Alberta Transportation Springbank Off-stream Reservoir Project

Response to NRCB and AEP Supplemental Information Request 2 November 18, 2019

June 2020

Figure 5-1

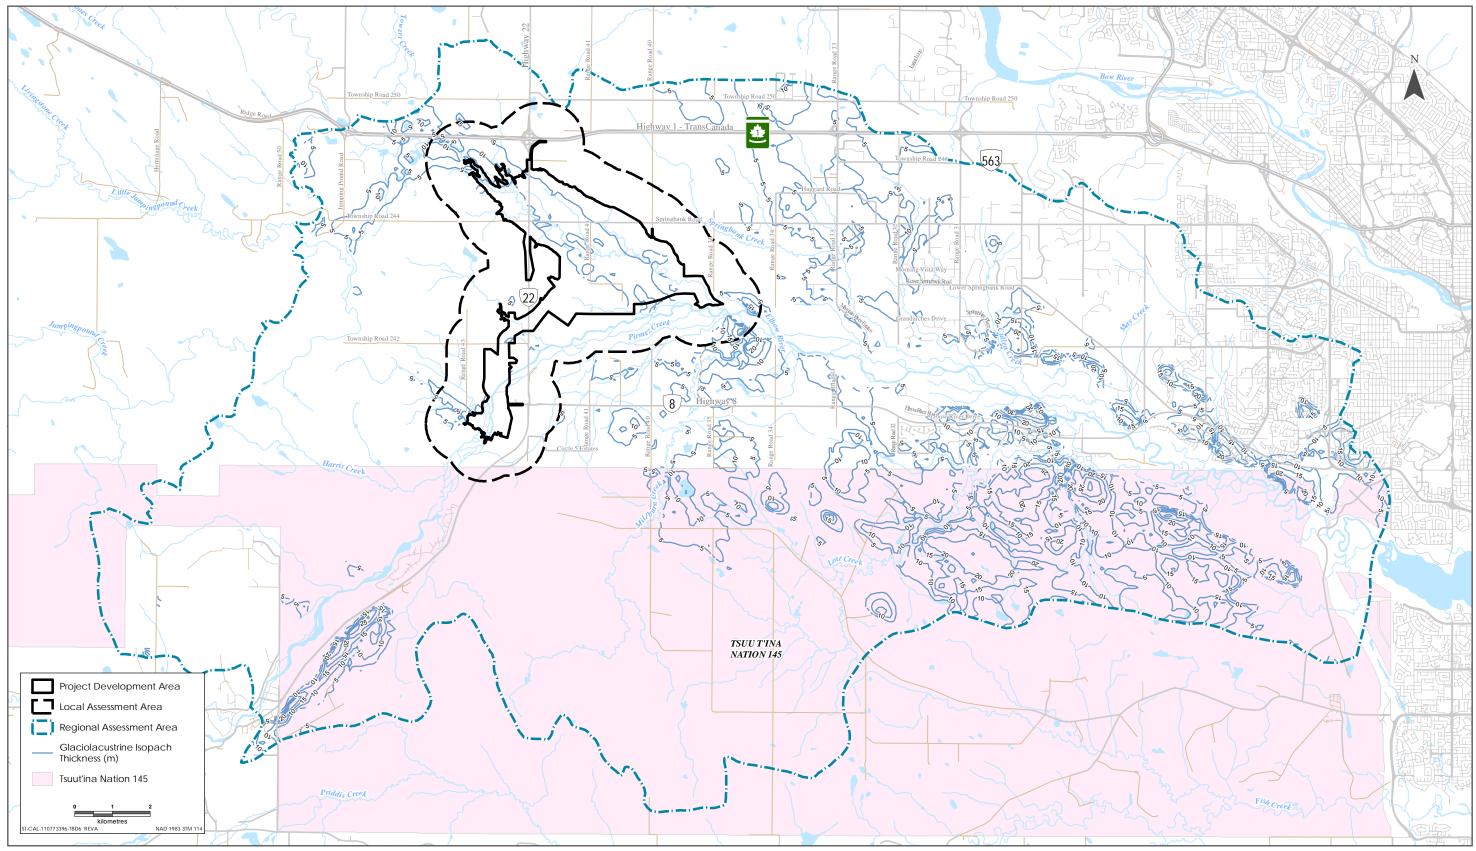
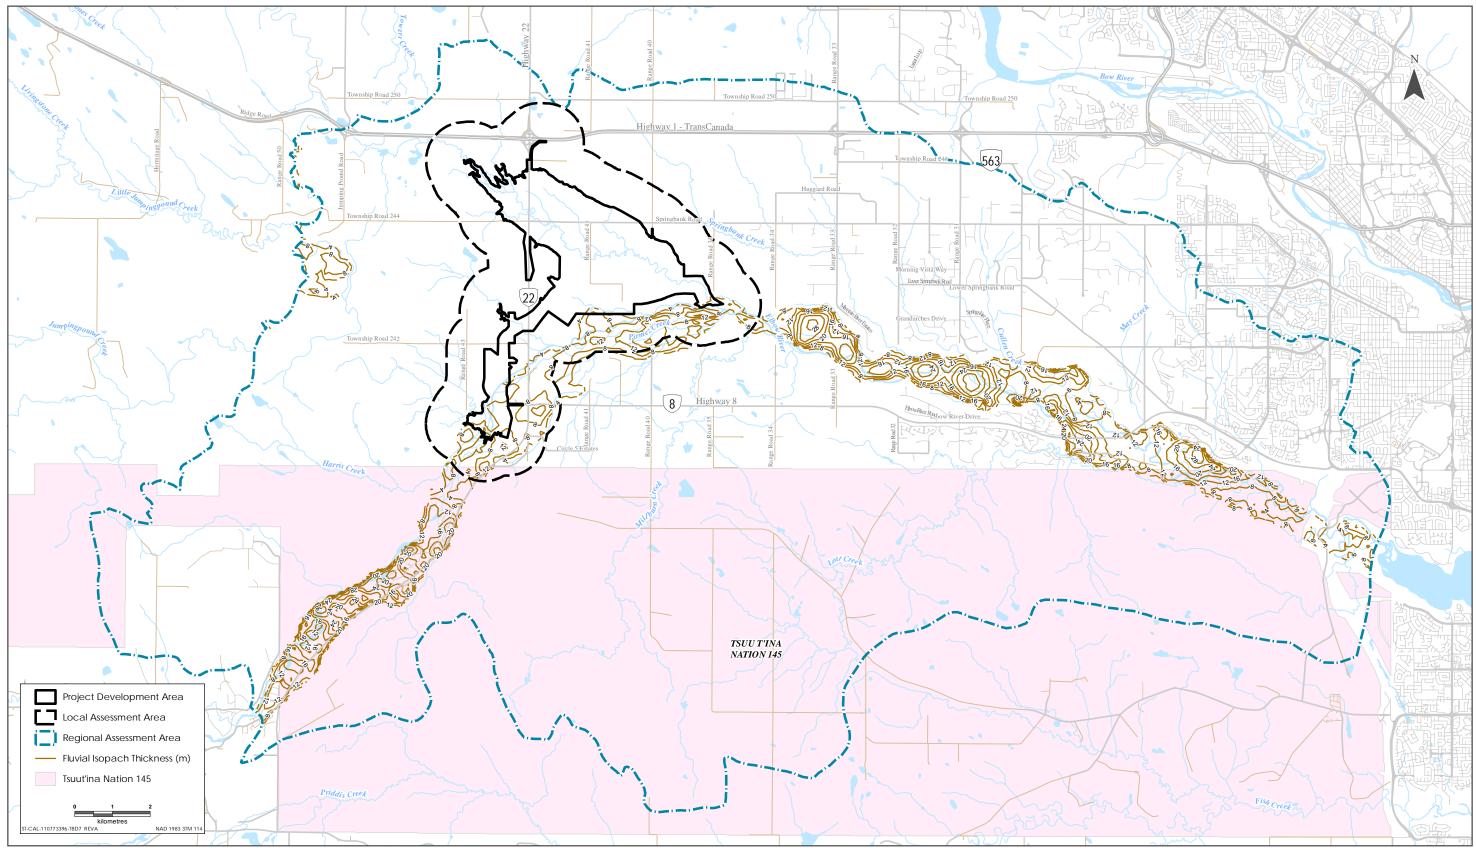
Figures 3-8, 3-10 and 3-12 in Appendix IR42-1 show isopach maps for glacial till, glaciolacustrine, and recent fluvial deposits. Contour labels are not shown for all areas in the expanded RAA and it is not obvious what they are.

a. Provide the missing labels for the isopach contours in the expanded RAA.

a. The contour labels in Alberta Transportation's response to Round 1 Natural Resources Conservation Board (NRCB) information request (IR)42-1, Appendix IR42-1, Figures 3-8, 3-10 and 3-12 have been revised in the following figures: Figure 5-1, Figure 5-2, and Figure 5-3.

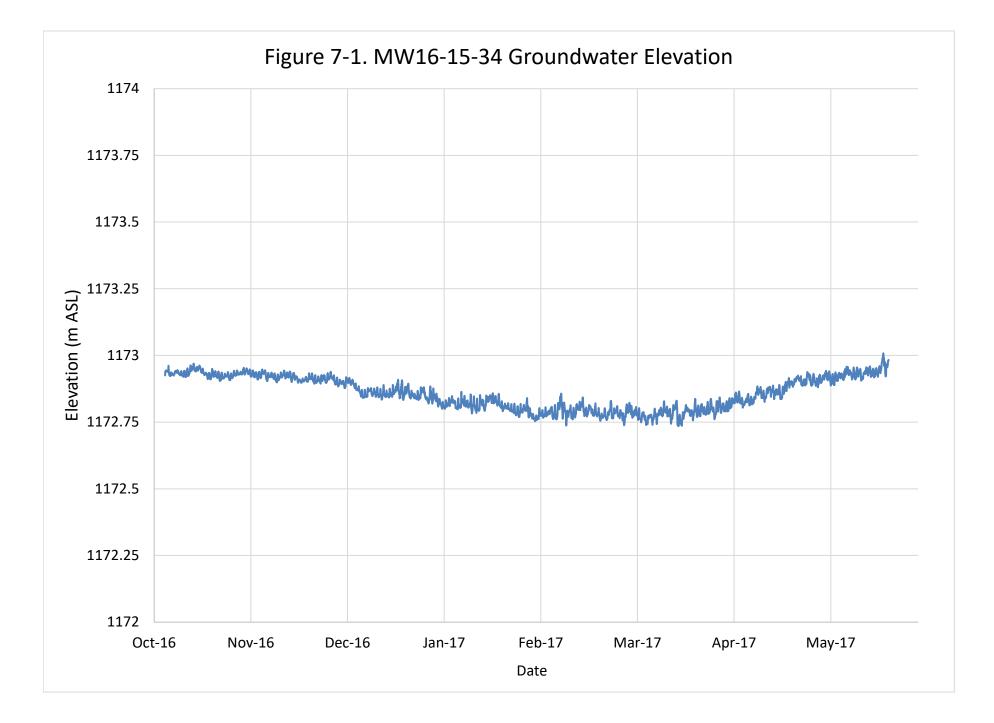
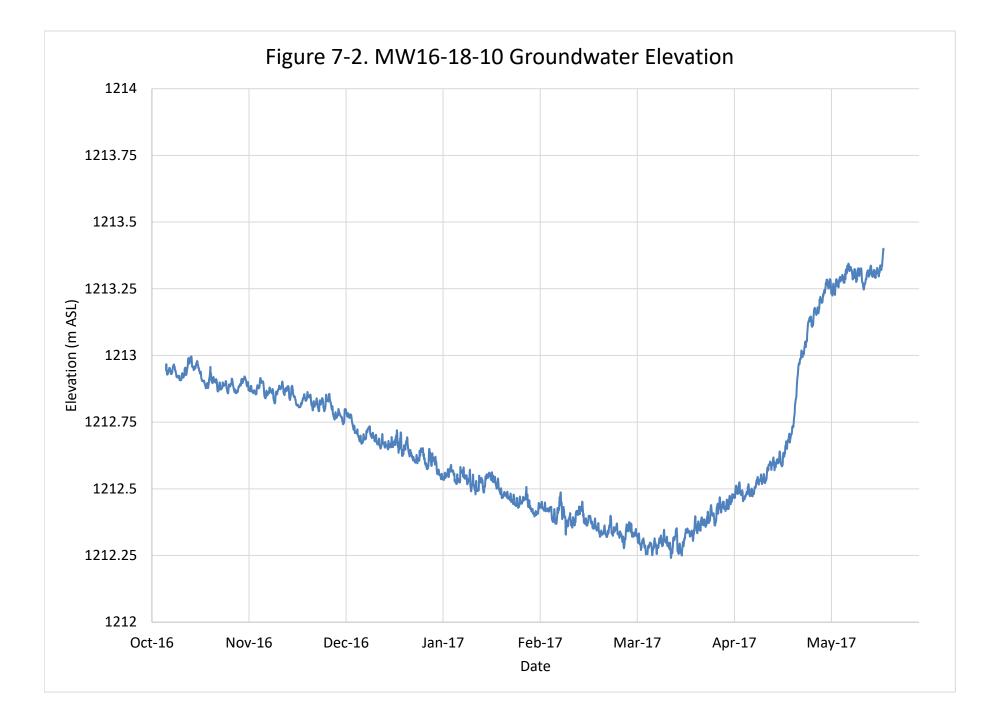
The hydrograph for monitoring well MW16-8-19 is repeated several times in Figure 3-26. Table 2-1 shows that pressure transducers were installed in MW16-15-34, MW16-7-5 and MW16-18-6 and these are not shown in the referenced figures. Figure 3-24 includes a hydrograph for monitoring well MW16-17-5, however Table 2-1 shows that no pressure transducer was installed.

The hydrograph for MW16-8-19 appears in Figure 3-25 and Figure 3-26 multiple times as an error and, as a result, the hydrographs for MW16-15-34 and MW16-18-10 were not included. These two hydrographs are provided in Figure 7-1 and Figure 7-2.

Figure 9-1

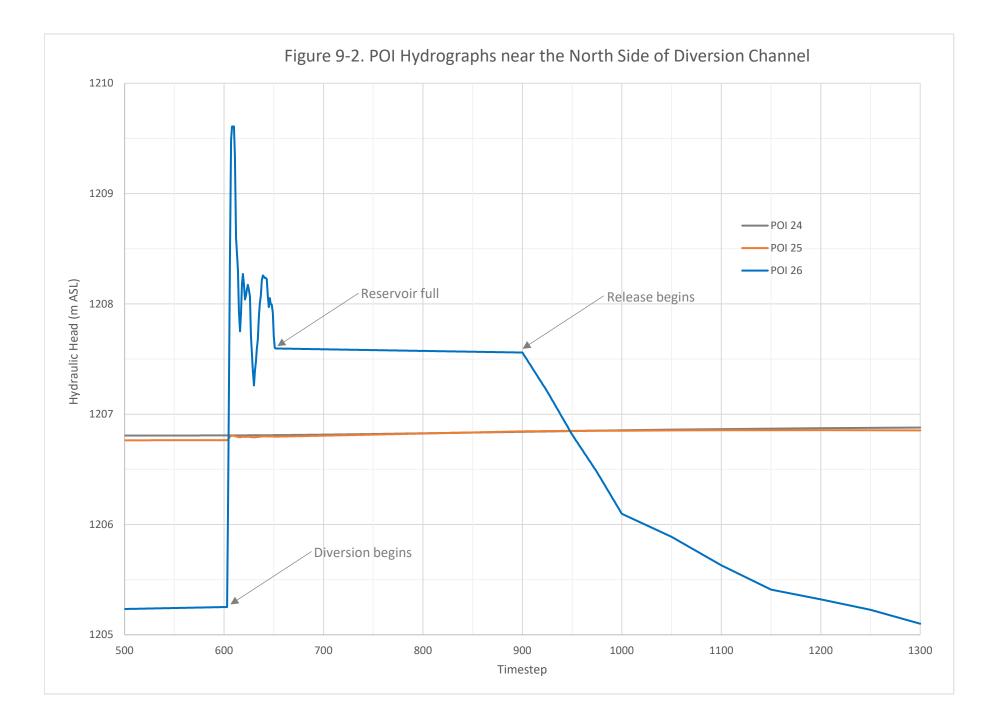
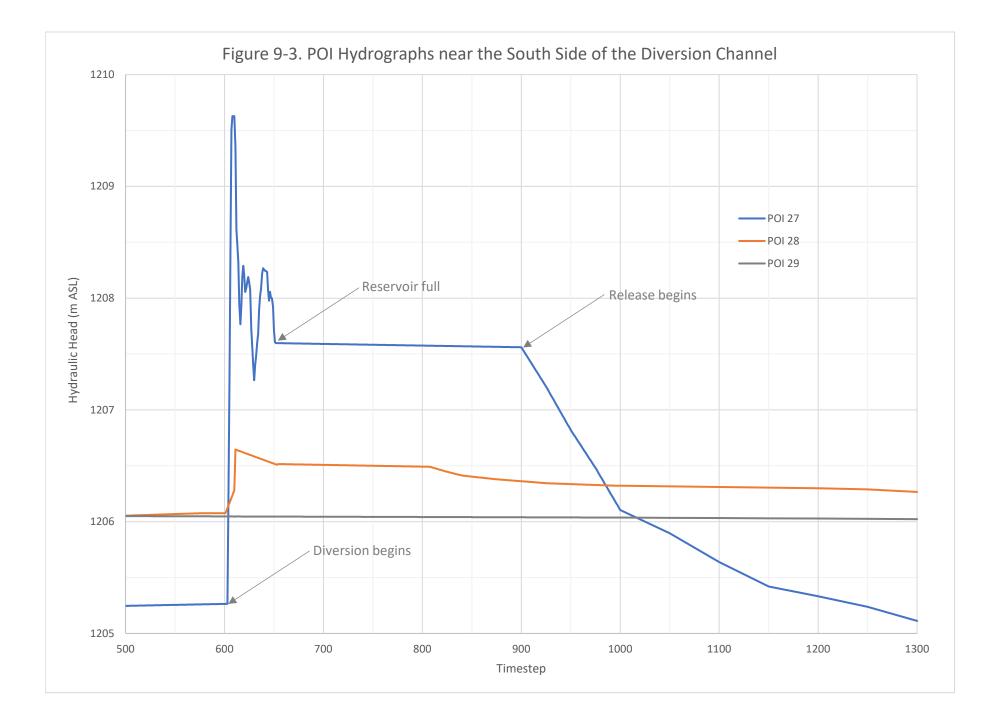
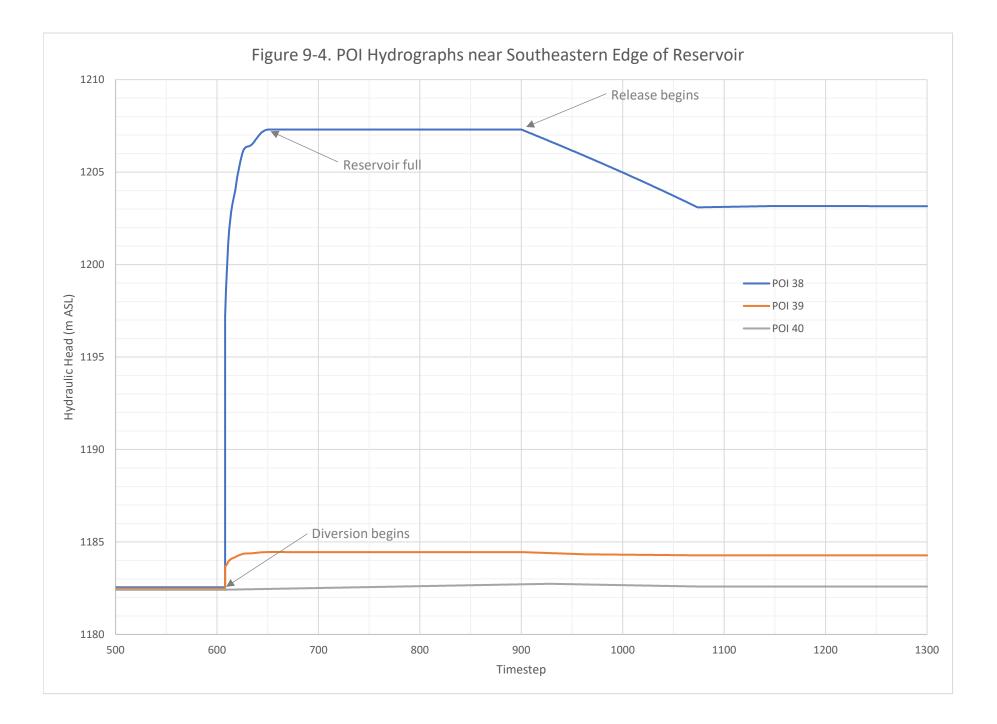
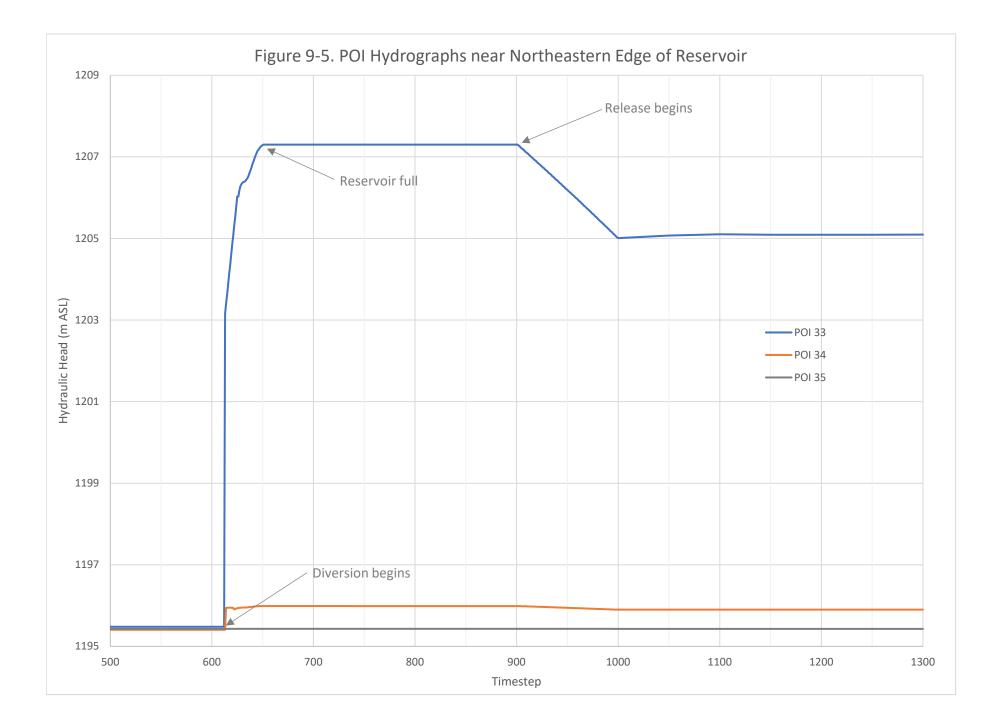
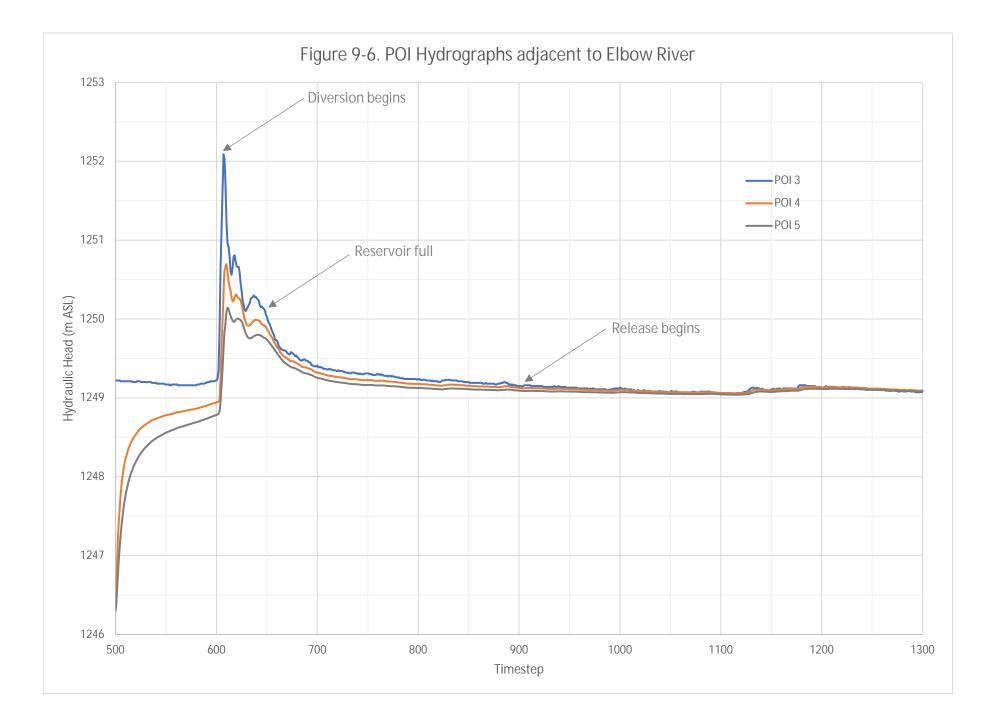
No time series plots are provided for the Points of Interest in Appendix IR42-1, Figure 5-4.

a. Figure 9-1 presents the locations of the points of interest (POI). The following discussion presents time series hydrographs for POI in areas near the diversion channel and reservoir. All timesteps referenced in Figure 9-2 to Figure 9-6 are one-hour increments of elapsed time since the start of the simulation for the design flood.
